Australian Energy Regulator
**Review of TasNetworks' proposed
capital expenditure for the 2019-24
regulatory control period**
Final draft report

Final draft | 10 August 2018

Arup was engaged by the Australian Energy Regulator (AER) to review TasNetworks' transmission and distribution network capital expenditure plans for the 2019-24 regulatory control period (RCP).

Figure 26 Trend in failure rates of CONSAC cables⁸⁷

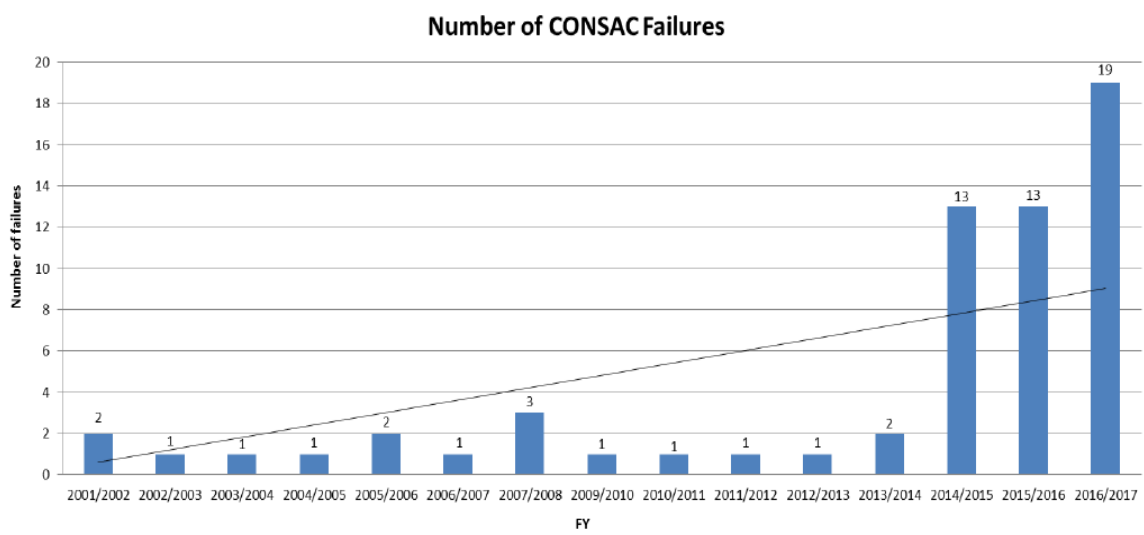
There were three CONSAC failures in 2008 failures according to Figure 26. TasNetworks' assertion that CONSAC cables were responsible for 70% of LV cable failures in 2008 suggests there were four LV cable failures that year. However, this does not match the 27 failures in 2008-09 indicated in the Underground System Distribution Asset Management Plan.⁸⁹

Figure 42 Wooden pole and staked pole age profile

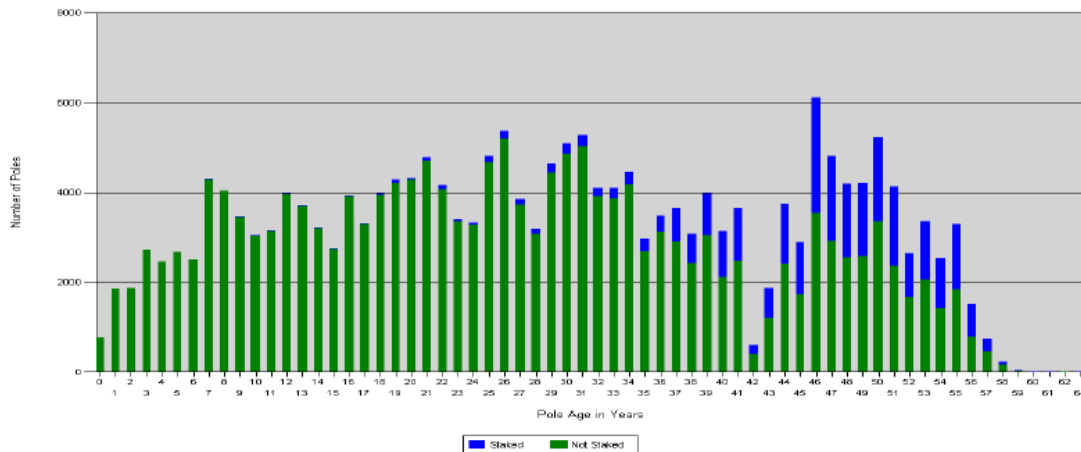
When compared to the age profile of the profile of the assets a replacement of 8,300 poles will condemn all poles that are more than 54 years old, and half of the population that are 53 years old. If TasNetworks is primarily replacing the 8,300 oldest poles this would equate to the removal of all staked poles that are more than 50 years old.

Figure 50 Proportion of customer contributions and net connection expenditure to gross connection expenditure¹⁷⁴

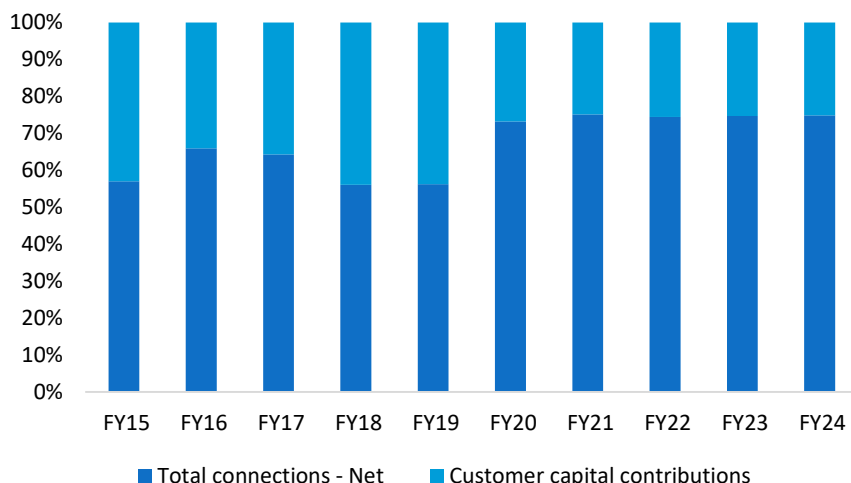
Arup has not seen any justification for the decreasing ratio of contributions to connections. TasNetworks has indicated it will review its forecasting methodology for capital contributions:
